**American River Flood Control District  
Central Valley Flood Protection Board Permit Application  
1870 Claremont Road**

**Staff Report**

**APPLICATION FOR A CENTRAL VALLEY FLOOD PROTECTION BOARD  
ENCROACHMENT PERMIT**

1870 Claremont Drive  
 Plan View and Cross Section

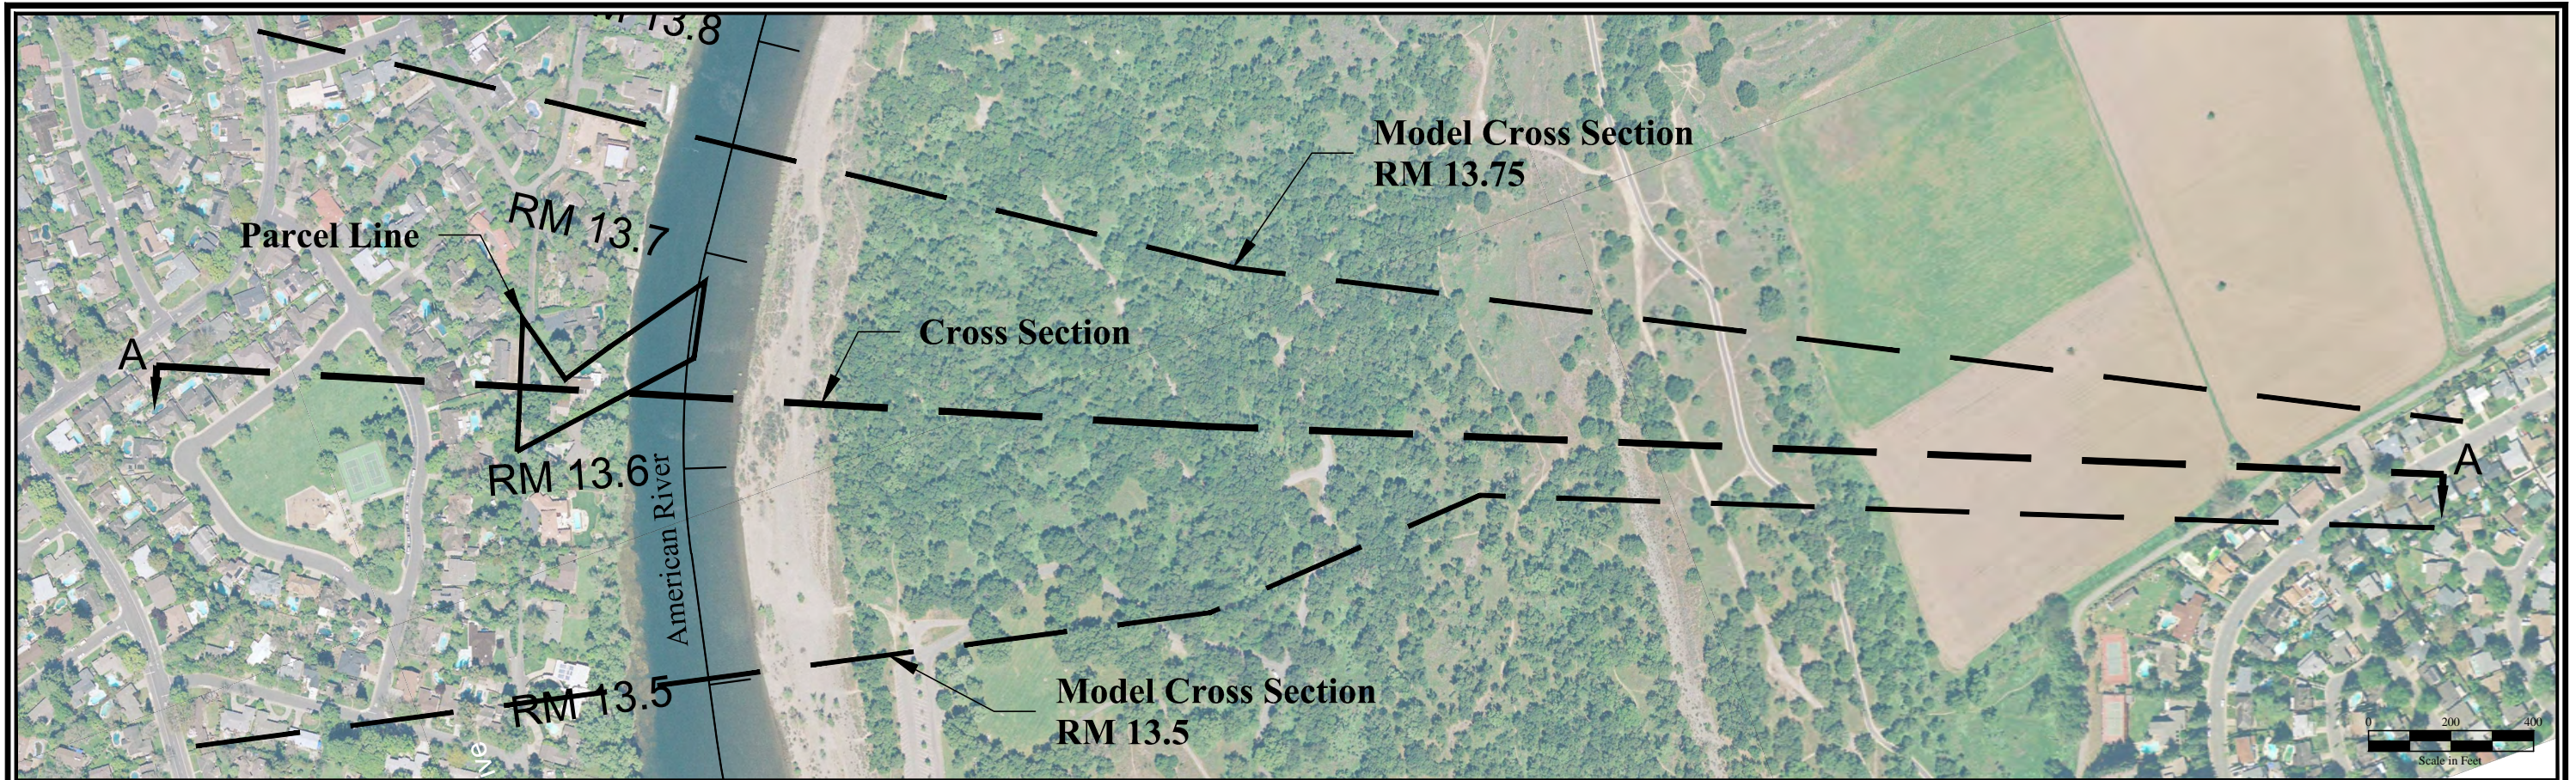
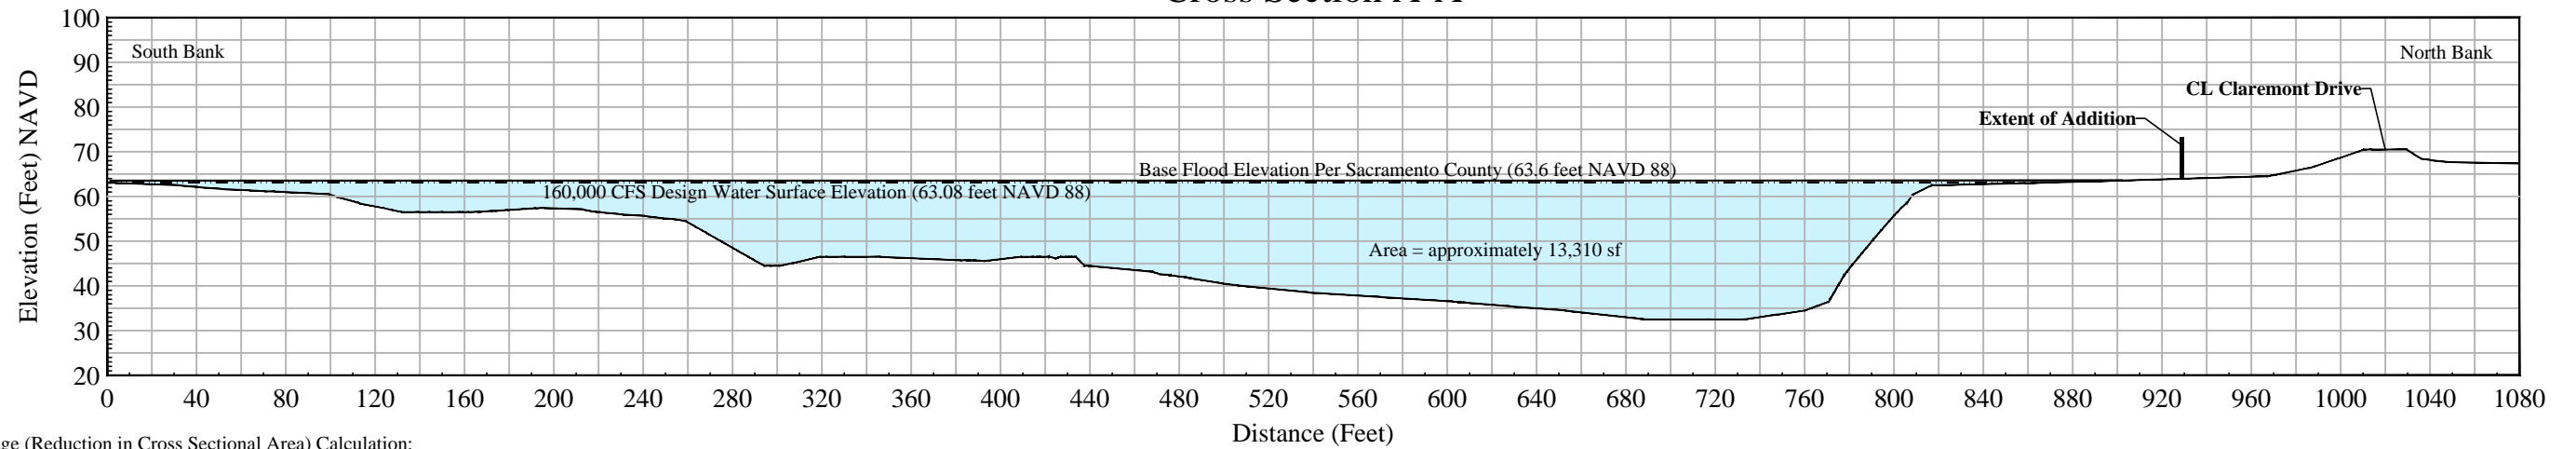
Blockage (Reduction in Cross Sectional Area) Calculation:

Additional Area within floodway: 37' largest cross sectional length of addition x 0.6' depth = 22.2 sf  
 Cross sectional area of floodway to design WSE\*: approximately 13,310 sf  
 Percentage of cross sectional area reduction\*\*: 0.17%

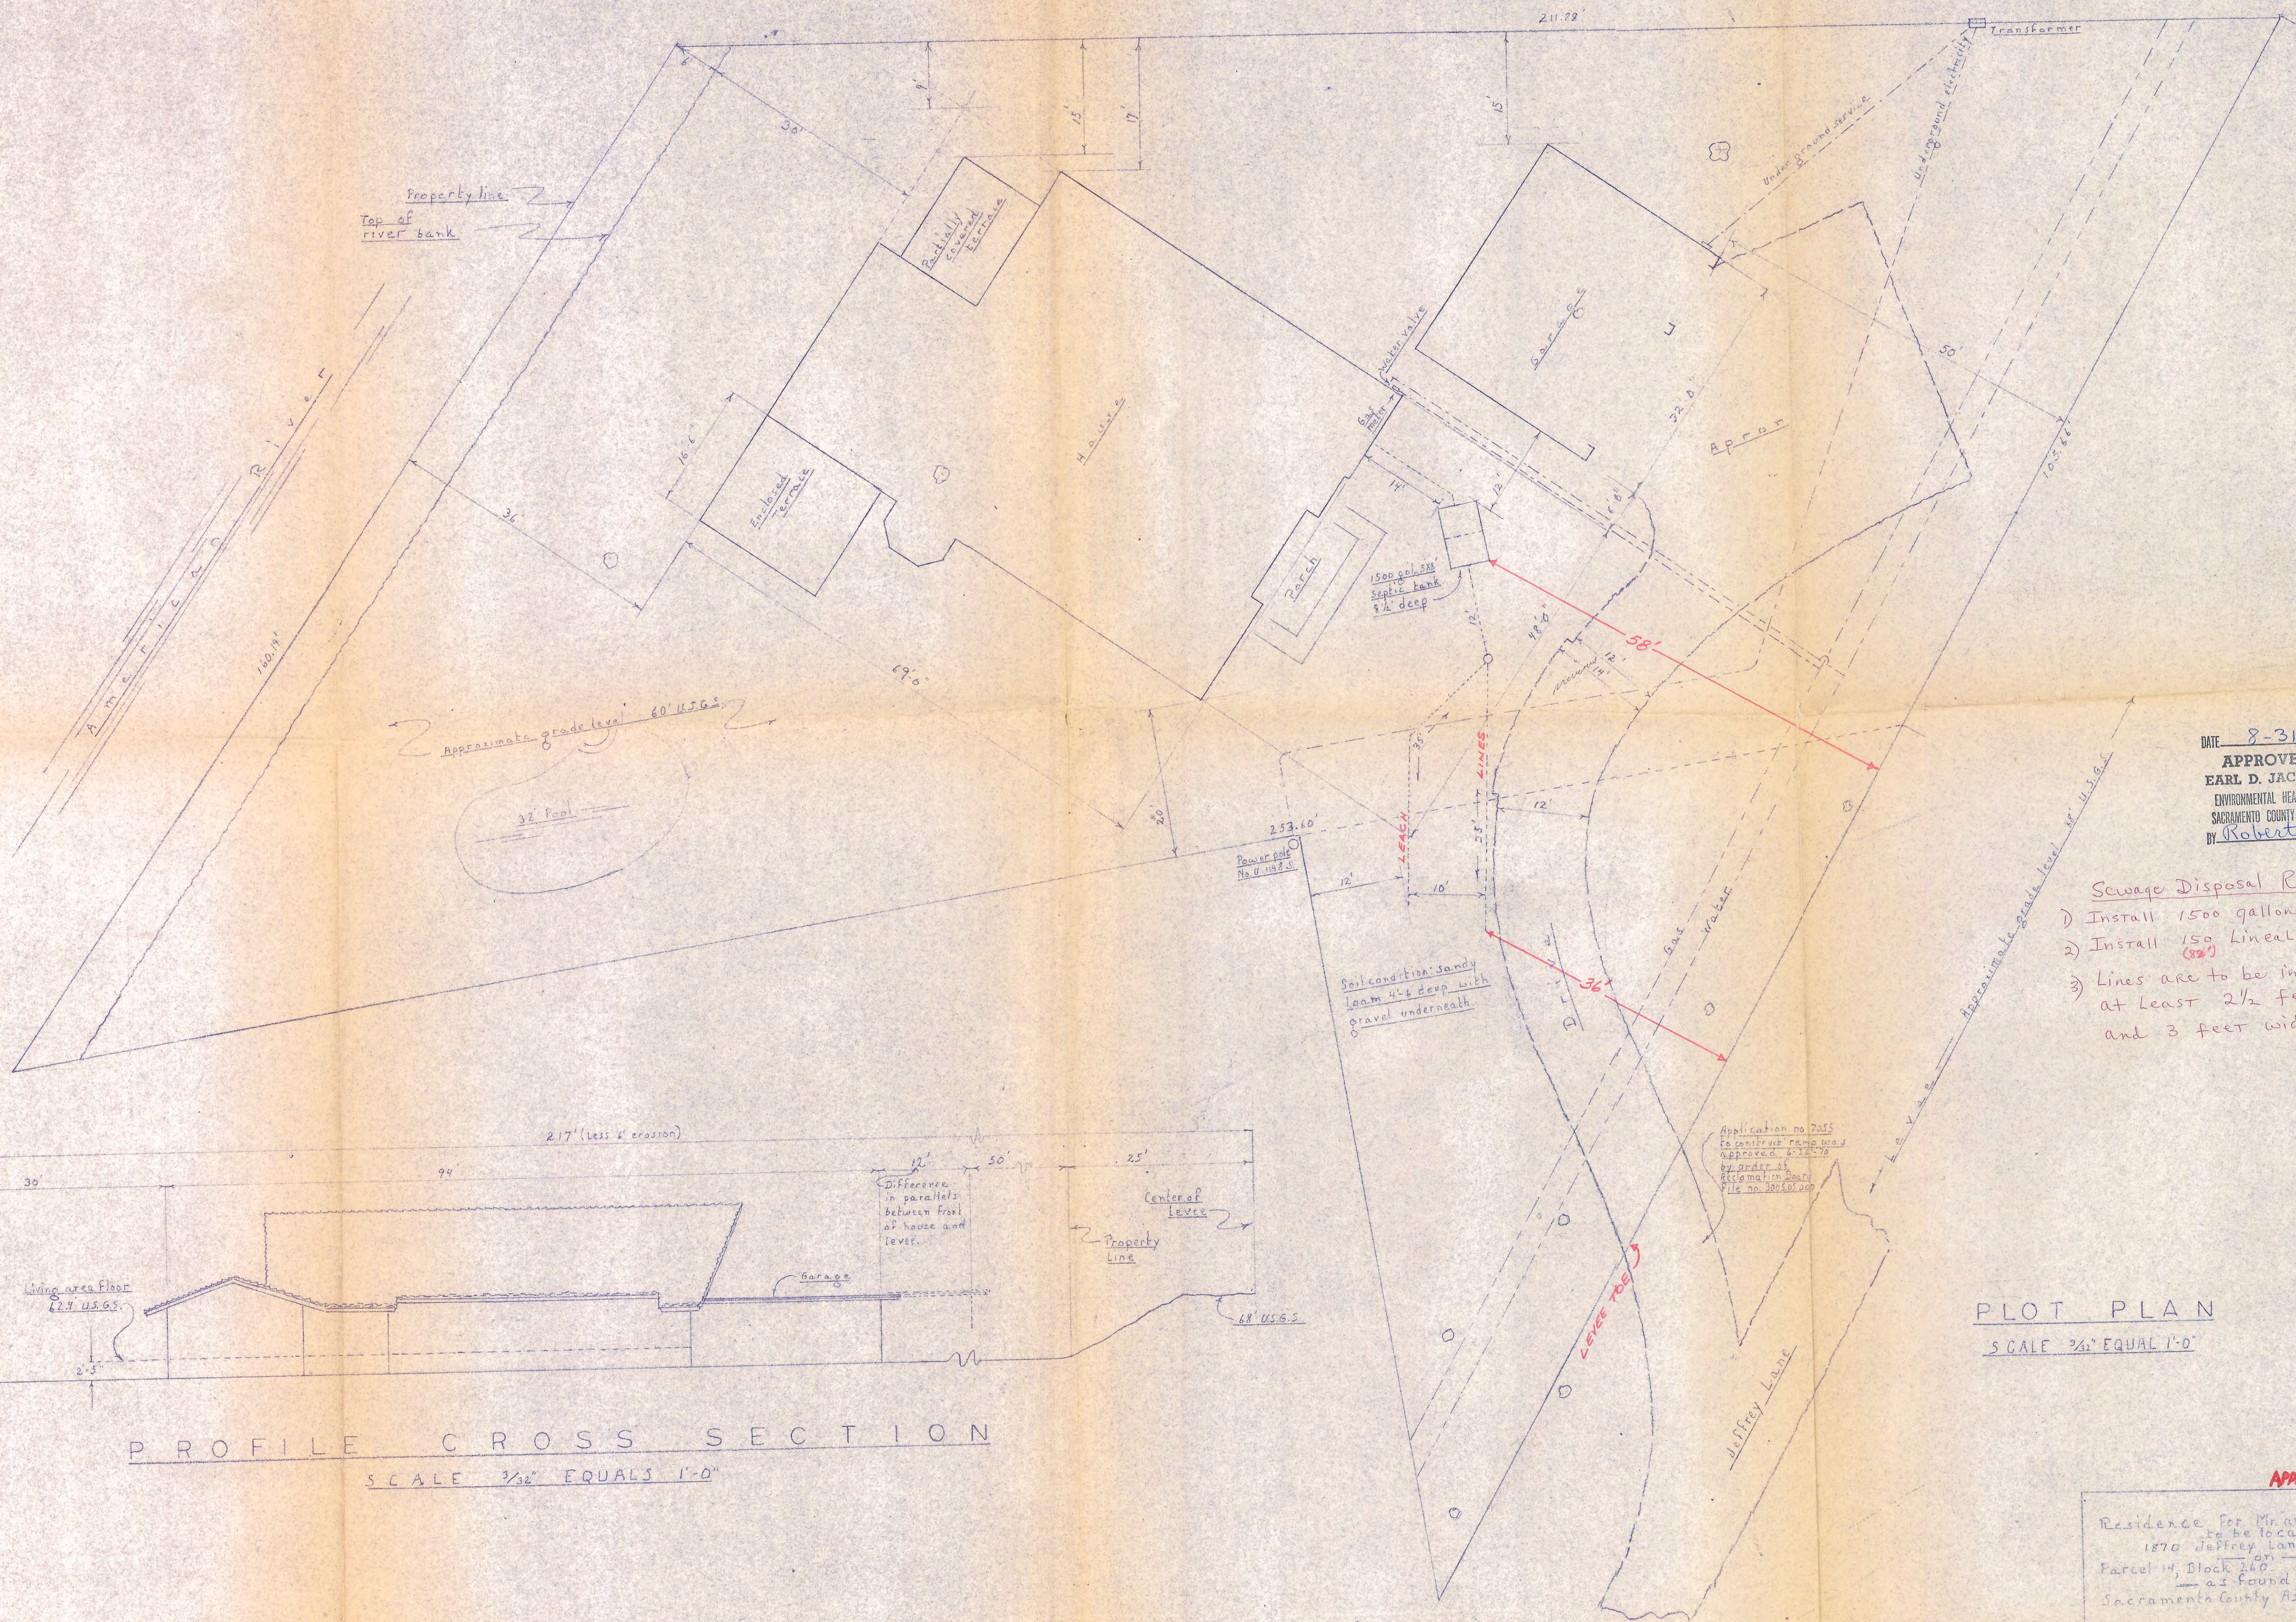
The District Engineer has no objection to approval of this application by your Board provided approval is subject to the following conditions:

- a. That the floor of the proposed dwelling shall be constructed to at least elevation 64.5, USGS datum, which is 2 feet above flood plane at 115,000 CFS.
- b. That no construction shall be done within 30 feet of the top of the riverbank or within 10 feet of the waterward toe of the project levee.
